<b>Docket Number:</b>	17-BSTD-02
<b>Project Title:</b>	2019 Title 24, Part 6, Building Energy Efficiency Standards Rulemaking
<b>TN #:</b>	222883
<b>Document Title:</b>	CalCERTS, Inc. Comments On Residential Appendix RA Language
<b>Description:</b>	N/A
<b>Filer:</b>	System
<b>Organization:</b>	CalCERTS, Inc.
<b>Submitter Role:</b>	Public
<b>Submission Date:</b>	3/5/2018 4:19:03 PM
<b>Docketed Date:</b>	3/5/2018

**On Residential Appendix RA Language**

RE: **CalCERTS Comments on Residential Appendix RA Language**

Figure 3 - House with attic insulation extending over conditioned and unconditioned spaces

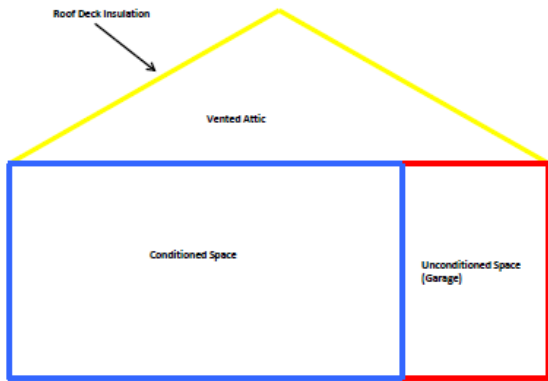
**RA3.5.3.3.4** We recommend clarifying the issue that was addressed in the Blueprint Newsletter, Issue #121, about attics over garages and some version of the following diagram be included:
